A RESOLUTION OF THE CITY COUNCIL OF THE CITY OF MERCED, CALIFORNIA, ADOPTING THE MERCED VISION 2030 GENERAL PLAN

MERCED VISION 2030 GENERAL PLAN OPTION 1

Proposed Changes Since August 2010 Public Review Draft

EXHIBIT B--Page 1 (Option 1)
ATTACHMENT 9B

Figure 4.27f Yosemite Avenue (East of Parsons/Gardner) Special Section

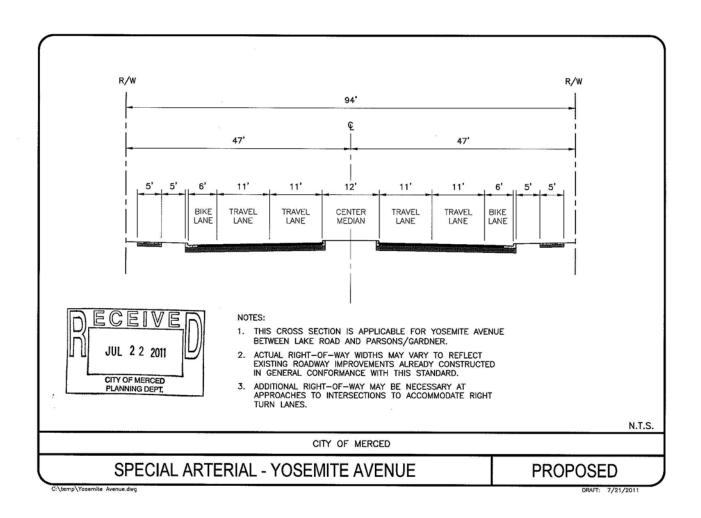
#	Pg.	¶	Col.	Change	Source
44	4-5			Figure 4.1-Circulation Plan should be modified to remove	CS/CL
				Kibby Road as a collector between Childs & Gerard per General	
				Plan Amendment #06-01, approved on Sept. 28, 2009, and to	
				change the designation for Yosemite Avenue, east of	
				Parsons/Gardner to a "Special Arterial" with a right-of-way of	
				94 feet and a cross section as shown in added Figure 4.27f (see
